Service Letter #: SL19 66-12700

Part #: 66-12731 Flexible Hydraulic Lines

Float Model Affected: Aerocet Model 6650 Floats, Kodiak Aircraft

Description of Change:

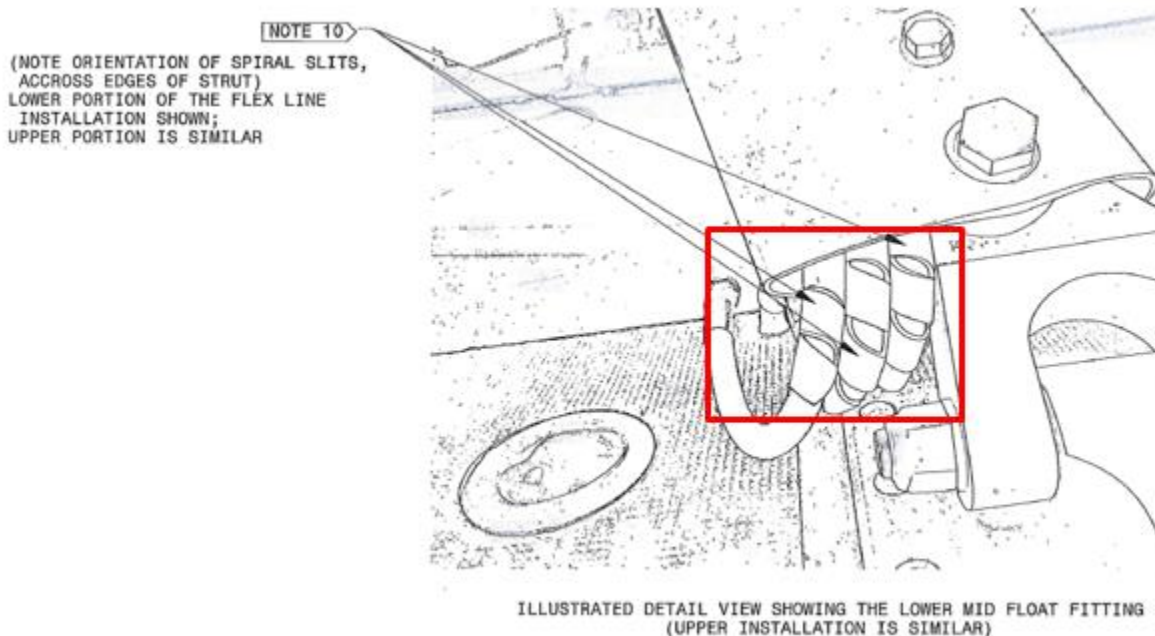
Reason for Change: Customer has option of switching to flexible hydraulic hose to replace hard tubing.

1. Apply flexible spiral wrap, approximately 6" length at possible contact points where hoses exit strut, top and bottom and at float and fuselage fittings. Spirals shall not align with contact edges. Reference 66-12700 drawing

2. Use $\varnothing 1/4$ " nylon 6/6, flame retardant spiral wrap, Thomas and Betts SRNY-250-9-C or equivalent.
